TECHNICAL BULLETIN

FA-A-0338-B

Re-indication of the UL Mark on MELSEC Programmable Controllers (Related to Noncompliance of Toyobo's PBT Resin with UL Requirements)

Position of the UL mark

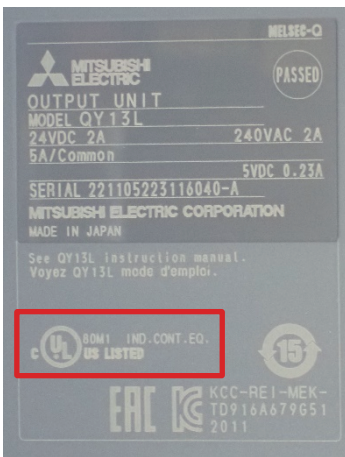
The UL mark is re-indicated on the parts for which material change has been completed and the products that use these parts.
